SERVICE BULLETIN REVISION TRANSMITTAL SHEET

MODEL BD-700-1A10 (BD-700)

Service Bulletin No. 700-31-026

MODIFICATION – FLIGHT DATA RECORDING-SYSTEM – INTRODUCTION OF A QUICK ACCESS RECORDER

KGC991-1294 – Kit – Installation of Quick Access Recorder (QAR)
(Sheet 1 of 2, Rev. C)

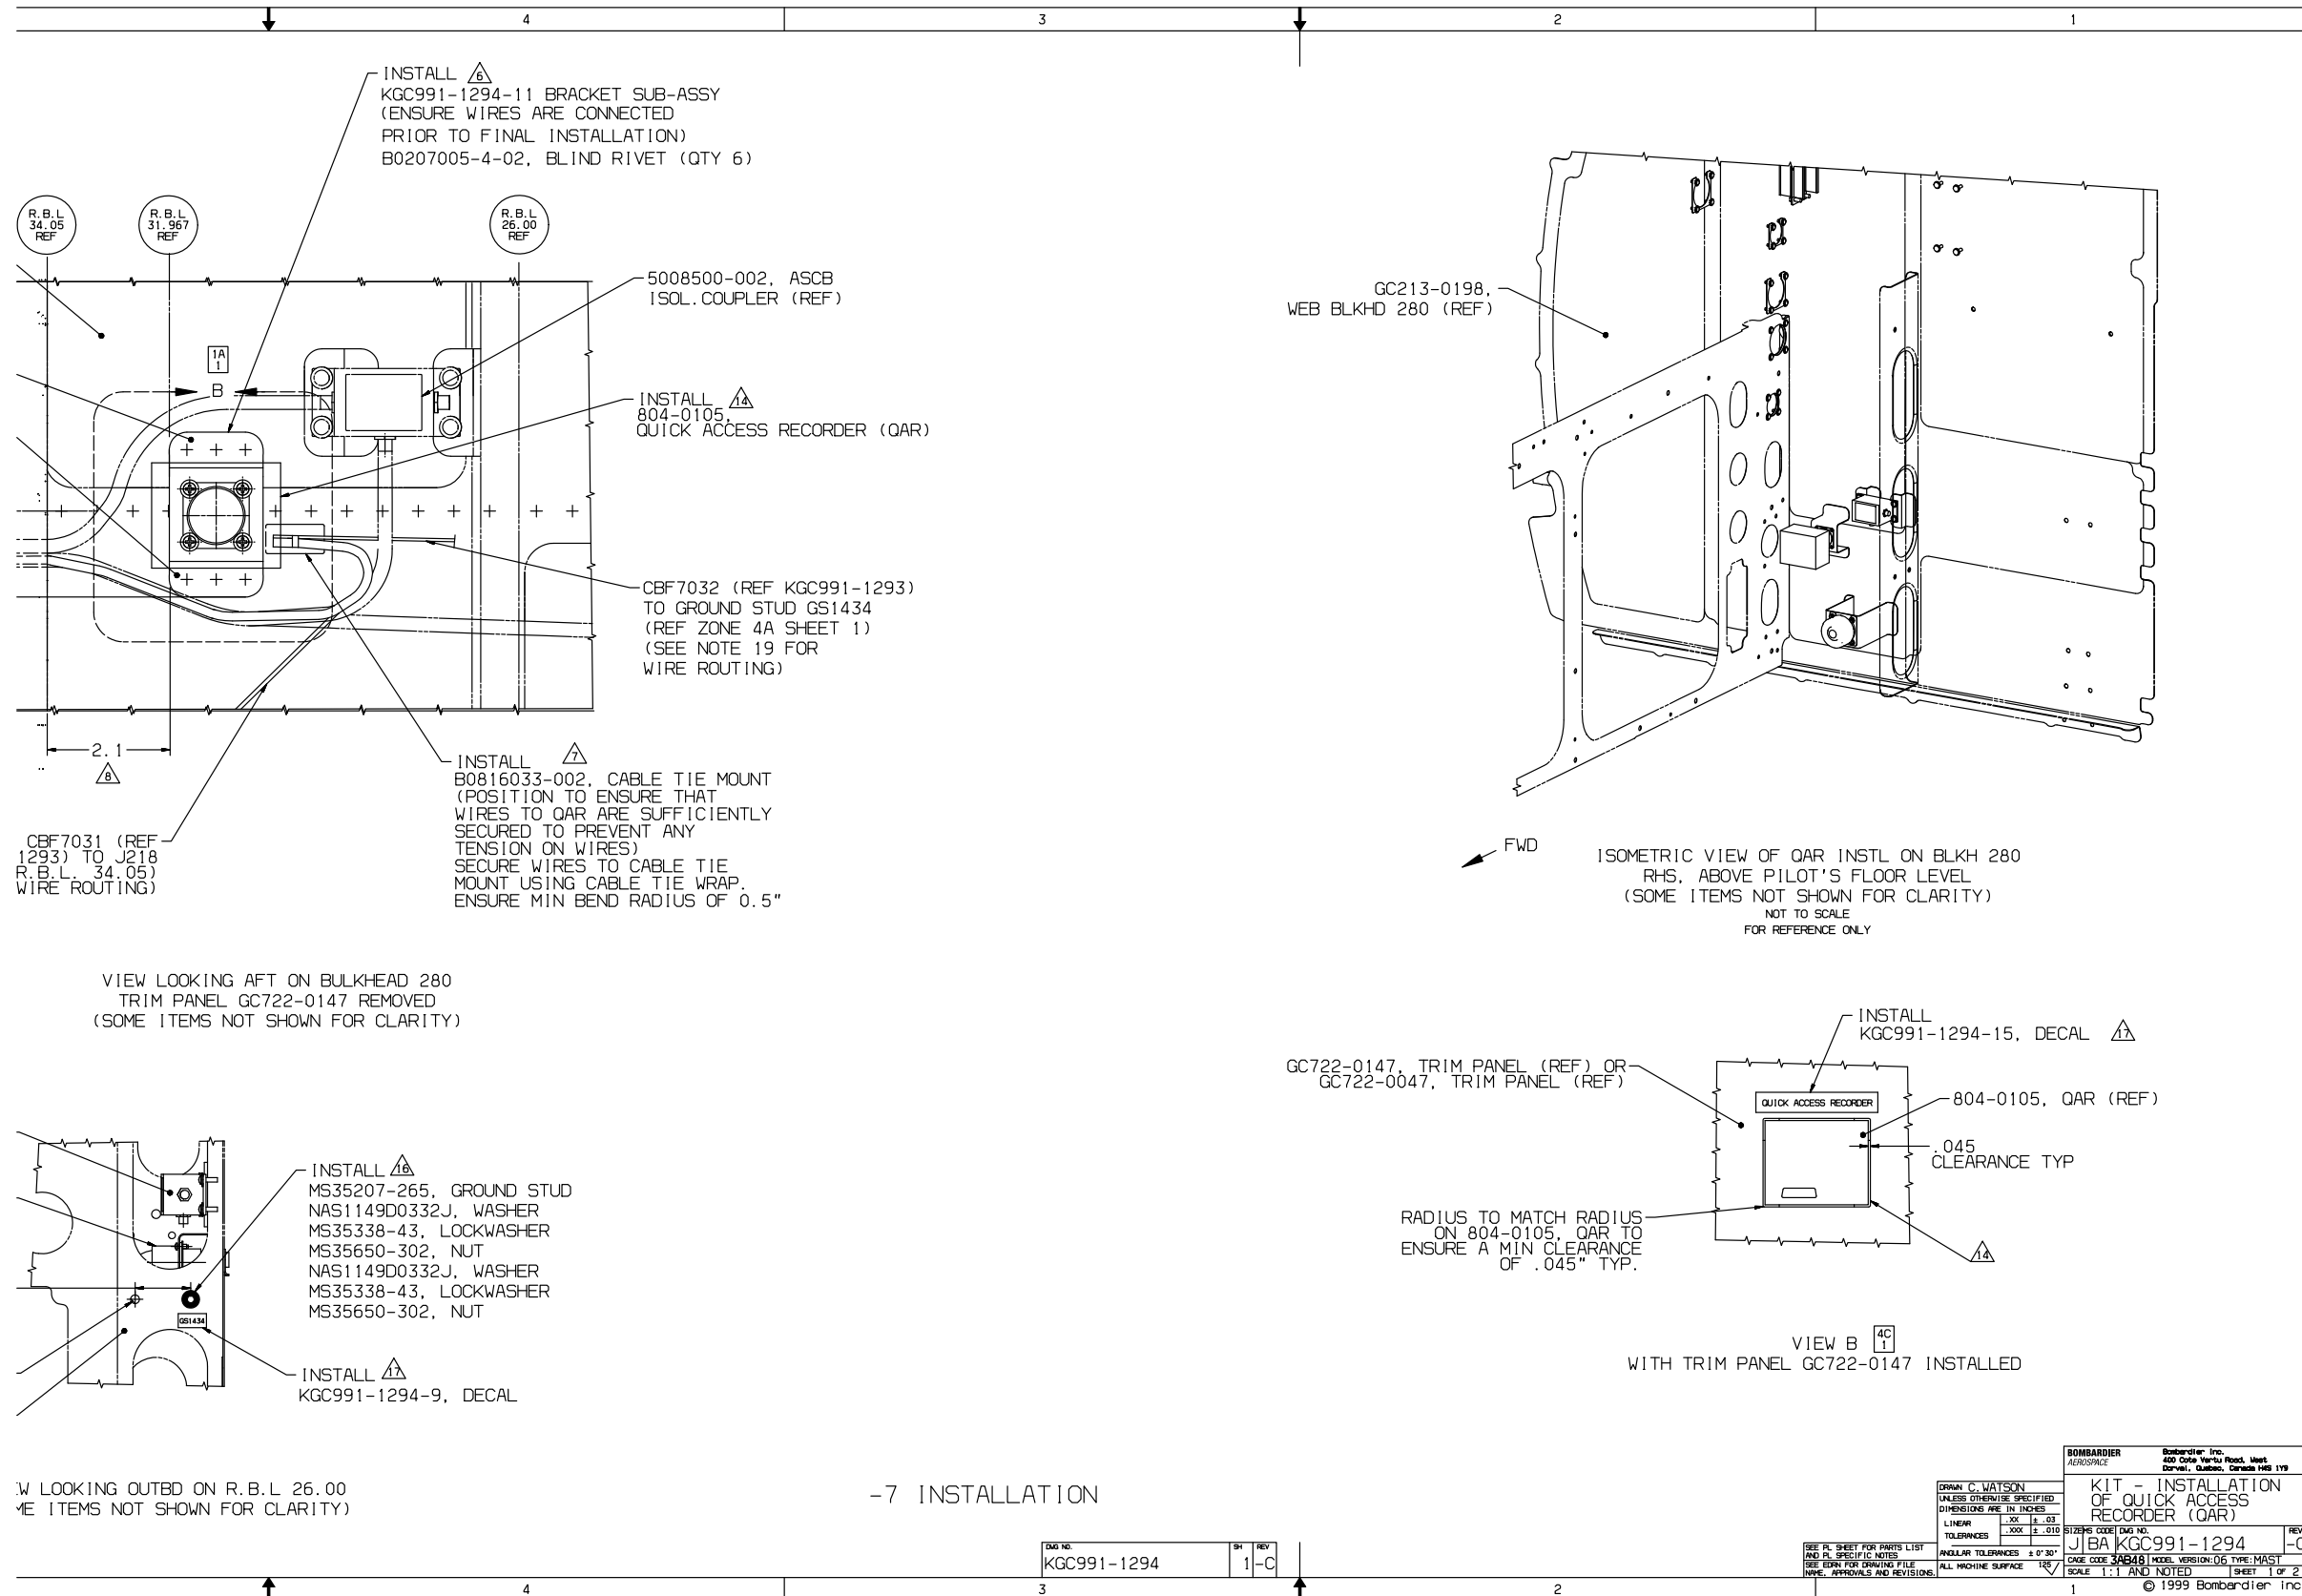
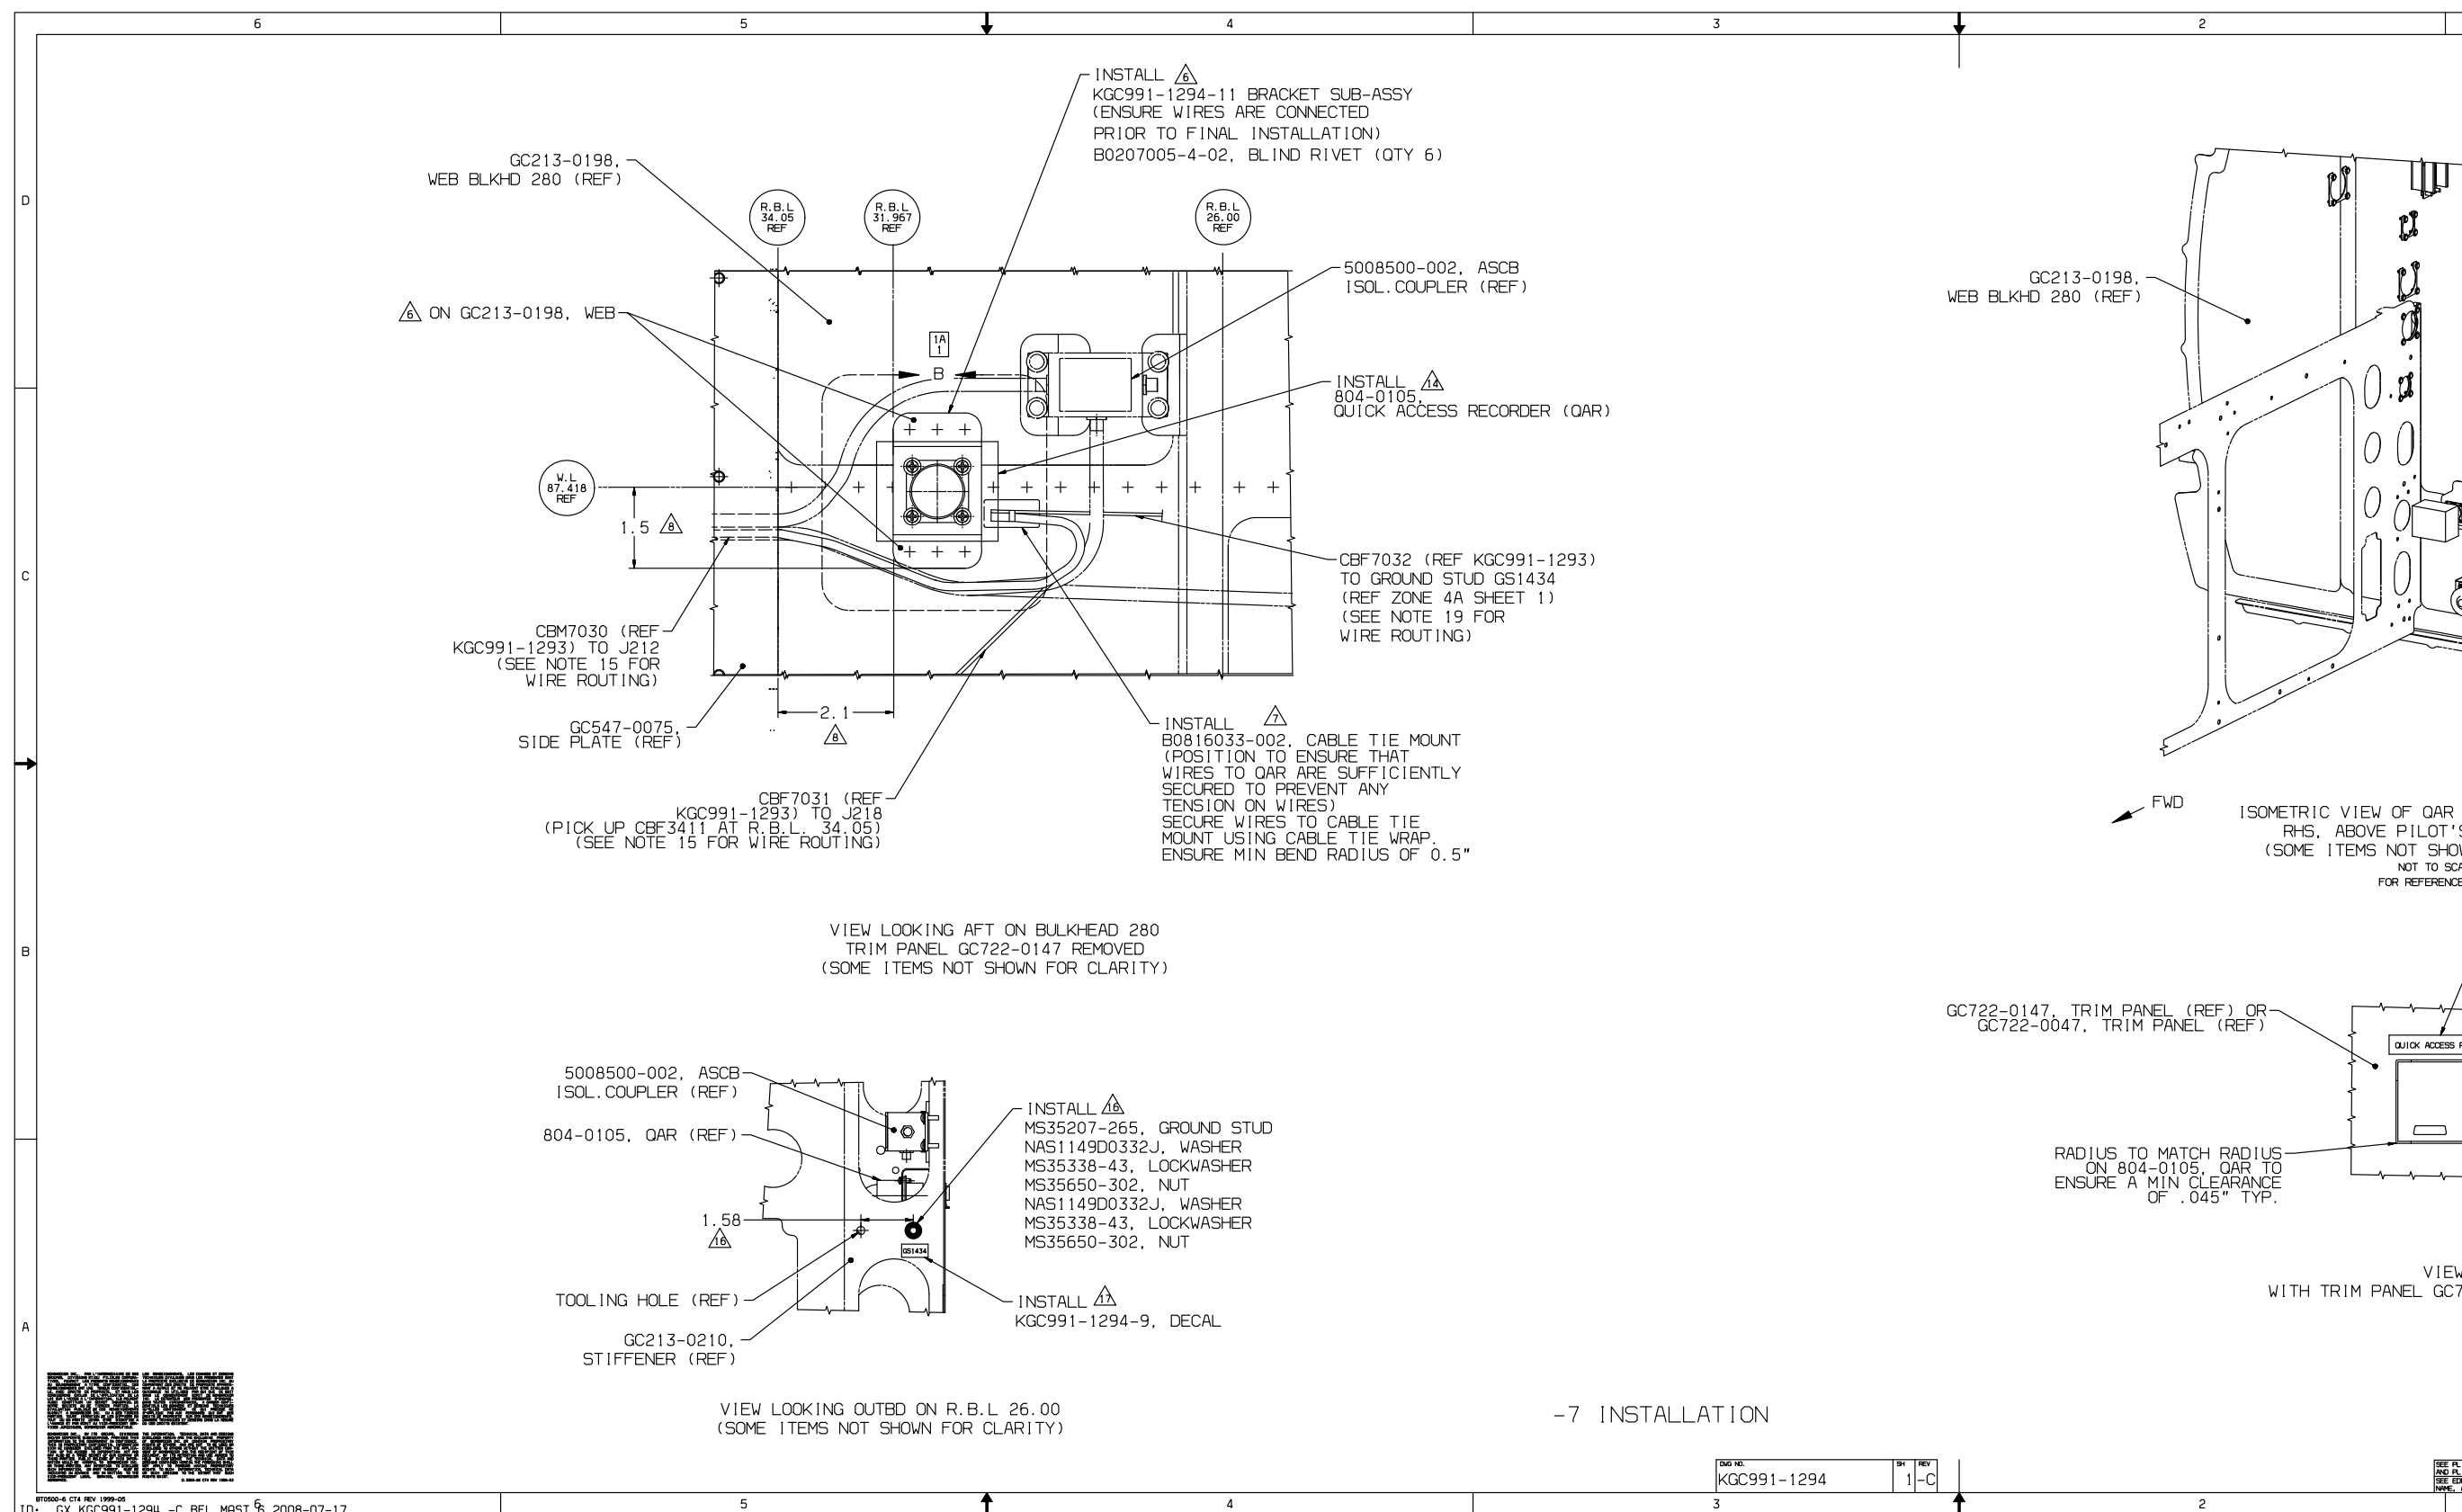
3. Change, in Paragraph 2.B.(1)(a) and other subsequent steps, the part no. of the bracket sub-assembly KGC991-1294-3 to KGC991-1294-11.
4. Change, in Paragraph 2.B.(2)(f)(iii), the part no. of the bracket KGC991-1294-5 to -13.

5. Add, in Paragraph 2.B., step (7): "Install decal Part No. KGC991-1294-15 above cut out as shown on Kit Drawing KGC991-1294. Refer to TASK 20-80-01-0400-801."

7. Change, in Paragraph 3.A., the part no. of the bracket KGC991-1294-5S to -13 or -13S.
8. Add, in Paragraph 3.A., DECAL Part No. KGC991-1294-15.
9. Replace revision B of Kit Drawing KGC991-1294 with revision C.

- (7) Install decal Part No. KGC991-1294-15 above cut out as shown on Kit Drawing KGC991-1294. Refer to TASK 20-80-01-0400-801.
 - (8) Install JB6. Refer to TASK 24-00-13-400-801
